# COPPER CHASE AT STERLING RANCH

# GRADING AND EROSION CONTROL PLANS

EPC STORMWATER REVIEW COMMENTS  
IN ORANGE BOXES WITH BLACK TEXT

# PUDSP22002-R1-Grading & Erosion Control Plan.pdf Markup Summary

**GRADING & EROSION CONTROL PLAN**

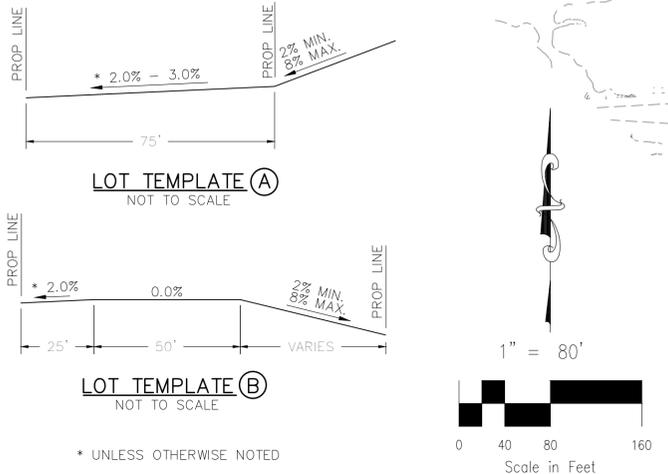
Items H and M. If "limits of disturbance" and "construction boundary" are the same, change to "limits of construction/disturbance" or otherwise show as separate line types for each on the legend and figure.

Item W. Provide construction fencing, barricades, and/or signage at access points not to be used for construction.

**CALLED OUT AS SAME LINETYPE**

**BARRICADE ADDED**
